## **FOUNDATION DESIGN SECTION**

*CONT 92-40*

Jersey Creek Concrete Culvert  
at  
Hwy. 407/CPR Subway

# FOUNDATION INVESTIGATION REPORT

## JERSEY CREEK CULVERT - SHAFT

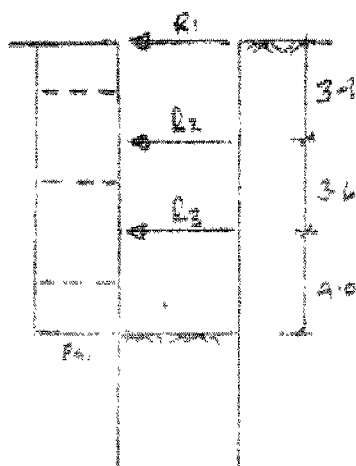
- Discussed attached calcs w. Bob Jeffries on 1993 03 18 PM.
- If Fenco's calcs indicate that a couple of walers are to be strengthened, they can propose that.
- Use of 0.35, with min. (>1.0) FS.
- Use of 0.2 may work, provided there is an arching effect.
- Acc to Bob. J., the shaft has already been constructed !! He is going to the site to verify this.

## JERSEY CREEK CULVERT - CPR DIVERSION

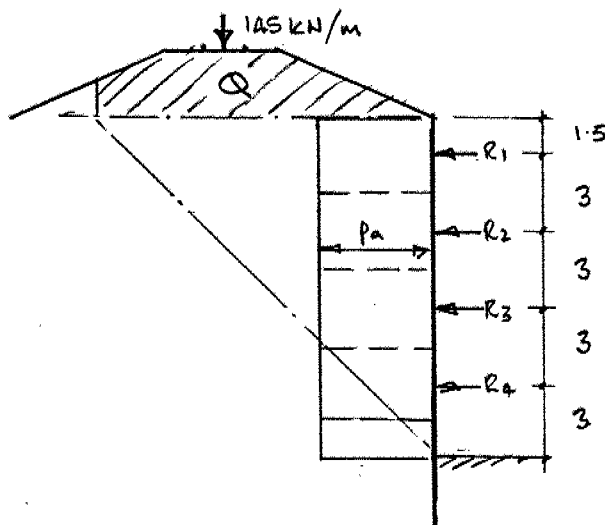
1. The critical location for pile and tiebacks design is at pile 8 as presented in design calculations. Cross sections in shoring drawing do not show the critical case. Actual height of soil retained at pile 8 appears to be more than 14 m as used in design calculations.
2. Provide design calculations for resisting the lateral force at bottom of piles.
3. Clarify how vertical load in pile resulting from tie-rod and tiebacks is resisted.
4. Specify size and grade of tie-rods and tiebacks.
5. Check adequacy of maximum load in tiebacks for piles 8 and 10 due to wider tributary load area.
6. Waler W460 x 74 spans approximately 4.8 m between piles 8 and 10. Provide design calculations for member.

1. Clarify whether compacted fill material can maintain vertical face for deadman trench.
2. Justify whether excavation slopes can be maintained at 1.5:1 and 1:1.
3. Clarify soil parameters used in shoring design calculations. Soil Report recommends  $\phi = 26^\circ$  ( $K_a = 0.39$ ) for silty clay material (EL 150.5 - 138.5). Design calculations used  $K_a = 0.35$ .
4. Check bond stress used for design of soil anchors.
5. Clarify the location of deadman for development of full capacity.
6. Anchorage zone of tiebacks should start beyond the theoretical sliding surface of the soil. Check adequacy of anchorage length provided.

PROVIDE 6m TOE F = 4. ✓

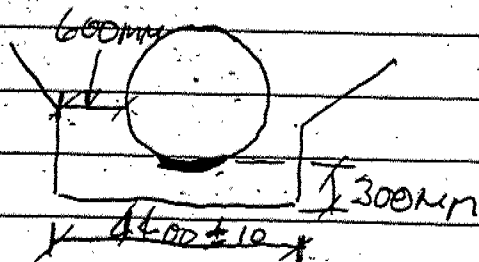
KINDLY BE ADVISED THAT GRAHAM BROS PROPOSES THE FOLLOWING BEDDING & BACKFILL IN AREAS WITH LESS THAN 2M COVER OVER THE PIPE.

BEDDING:- 300MM UNDER PIPE UP TO - HL 6 STONE  
SPRING LINE

B'FILL :- SPRING LINE OF PIPE - NATIVE FILL TO  
& ABOVE 95% COMPACTION

NB NATIVE B'FILL TO BE STONE FREE WITHIN 2M OF PIPE
